Illinois Department of Transportation

SUBJECT: FAU 8048 (Woodside Road)
Section 07-00090-09-FP
Sangamon County
Contract No. 93686
Item 63
August 4, 2017 Letting
Addendum (B)

NOTICE TO PROSPECTIVE BIDDERS:

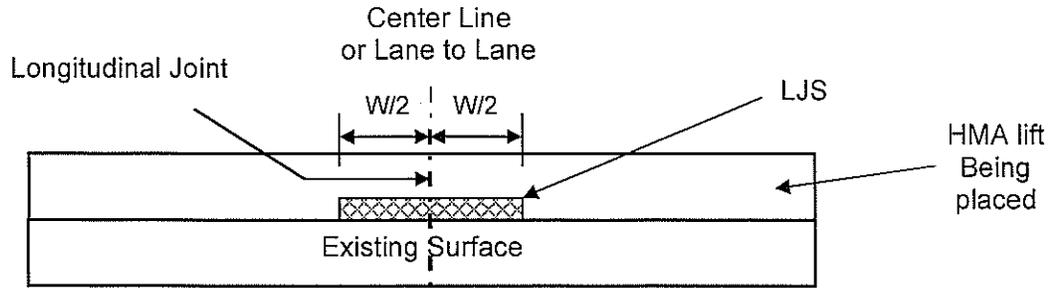
A notched wedge longitudinal joint shall be used between successive passes of HMA binder course that has a difference in elevation of greater than 2 in. (50 mm) between lanes on pavement that is open to traffic.

The notched wedge longitudinal joint shall consist of a 1 to 1 1/2 in. (25 to 38 mm) vertical notch at the lane line, a 9 to 12 in. (230 to 300 mm) wide uniform taper sloped toward and extending into the open lane, and a second 1 to 1 1/2 in. (25 to 38 mm) vertical notch at the outside edge.

The notched wedge longitudinal joint shall be formed by the strike off device on the paver. The wedge shall then be compacted by the joint roller.
